Project	IEEE 802.16 Broadband Wireless Access Working Group < http://ieee802.org/16 >	
Title	Modified Pilot Allocation for downlink STC PUSC	
Date Submitted	2004-08-17	
Source(s)	Erik Lindskog, Tareq Al-Naffouri, Brett Schein, K. Giridhar, David Garrett, Taiwen Tang, Kamlesh Rath, Sriram Modulodu, A. Paulraj, Babu Mandava, Robert Lorenz, and Aditya Agrawal, Beceem Communications, Inc. Freedom Circle, Suite 101 Santa Clara, CA 95054	Voice: +1-408-387-5014 Fax: +1-408-387-5010 elindskog@beceem.com
Re:	IEEE 802.16e D5 Draft	
Abstract	We propose a modification of the pilot allocation scheme in the PUSC mode for the two and four antenna case in the down link. This pilot allocation enhances the channel estimation performance for highly frequency selective channels, without incurring any extra overhead and without affecting the existing subcarrier permutations.	
Purpose	To propose enhancements to the pilot allocation for downlink STC PUSC in 802.16e/D5.

Modified Pilot Allocation for Downlink STC PUSC

Figure 1(b) Modified pilot allocation for PUSC (two antennas case)

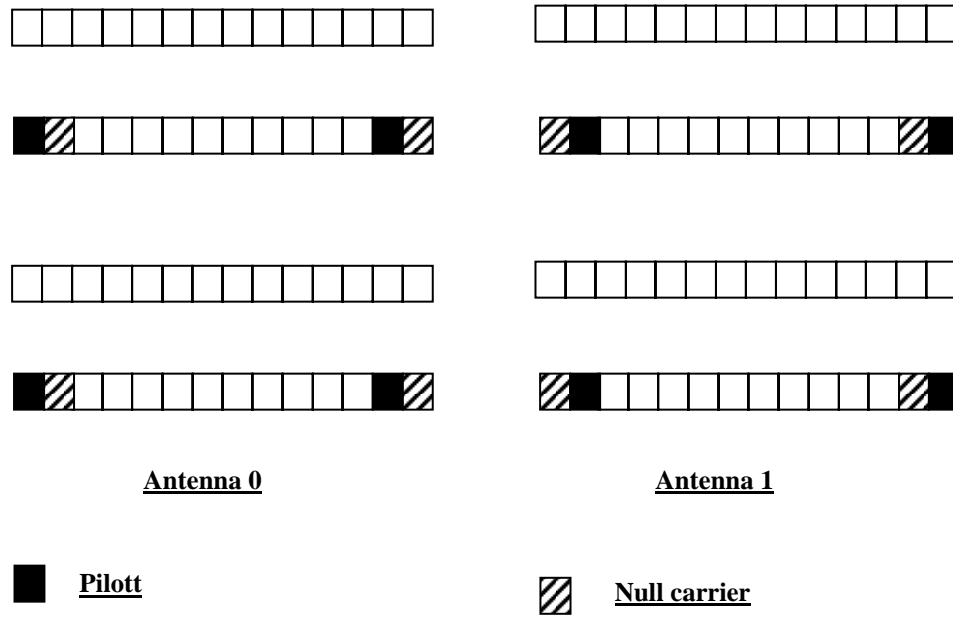
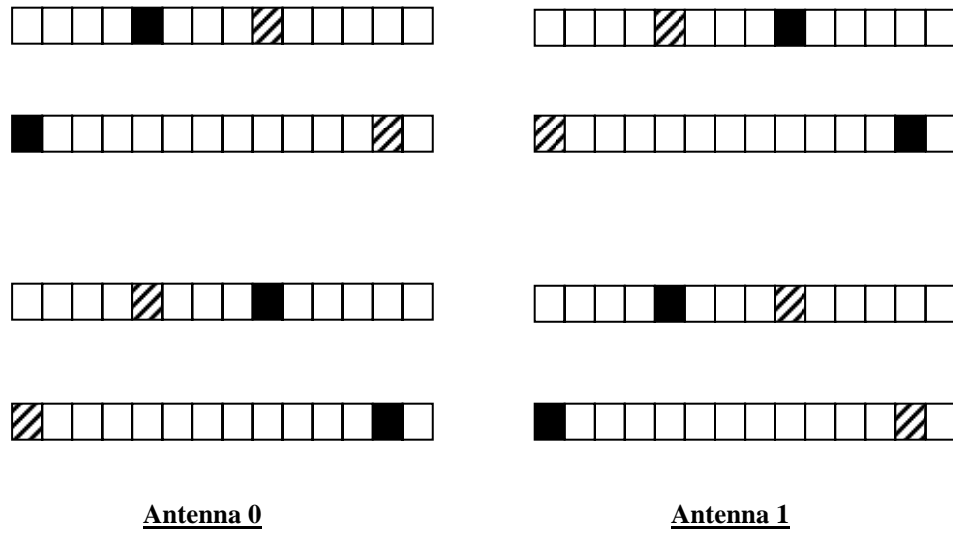
The current pilot allocation scheme in the PUSC mode for the 2 antenna case is as described in the cluster structure of Figure 245 (p. 584) and reproduced in Figure 1(a). It is easy to see that the overhead of pilots and null carriers is 2 carriers/OFDM symbol/antenna and that it allows us to estimate (on average) 1 frequency bin/OFDM/antenna. We propose instead to replace it with the pilot configuration shown in Figure 1(b). This pilot configuration doubles the number of frequency bins that can be estimated for the same overhead of 2 carriers/OFDM symbol/antenna. Moreover, this new configuration captures more of the frequency diversity as the pilot locations rotate from one symbol to the next. The only assumption made here is that the channel remains constant over 4 OFDM symbols (but this is a necessary condition anyway for ST coding to work).

In section 8.4.8.1.2.1.1 STC using 2 Antennas in PUSC, replace the first two lines

In PUSC the data allocation to cluster is changed (Figure 245) to accommodate two antenna transmission with the same estimation capabilities, each cluster shall be transmitted twice from each antenna

In PUSC the data allocation to cluster is changed according to the pilot allocation in Figure 1(b).

Figure 2 Modified pilot allocation for PUSC (four antenna case)

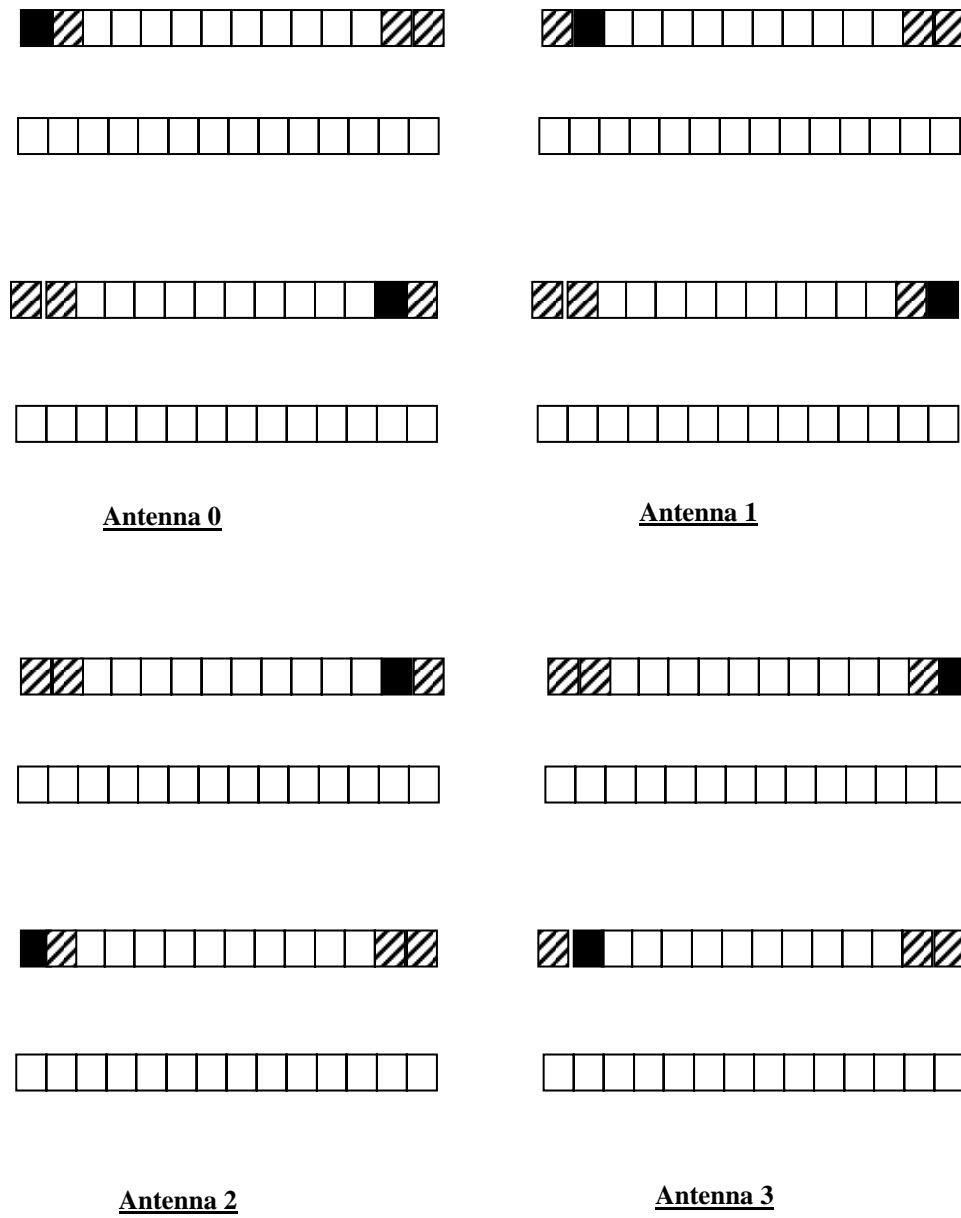
The current pilot allocation scheme in the PUSC mode for the 4 antenna case is as described in the cluster structure of Figure 251 (p. 589). This configuration has an overhead of 4 carriers/ofdm-symbol/antenna and it allows us to effectively estimate 1 frequency-bin/per 2 OFDM symbol/per antenna. Moreover, we are forced to perform data puncturing to create enough space for pilots. We propose instead the pilot configuration in Figure 2 which allows to estimate the same effective number of frequency bins, namely 1 frequency-bin/per 2 OFDM symbol/per antenna, for half the overhead. This allows us to reduce the overhead (and hence avoid the need for data puncturing). The scheme assumes that the channel remains fixed over the ST block which is a prerequisite for ST coding to work.

In section 8.4.8.2.1 STC for 4 antennas using PUSC, replace the whole text with the following text

For this configuration, two consecutive clusters are constructed according to Figure 2 to accommodate transmission from 4 antennas
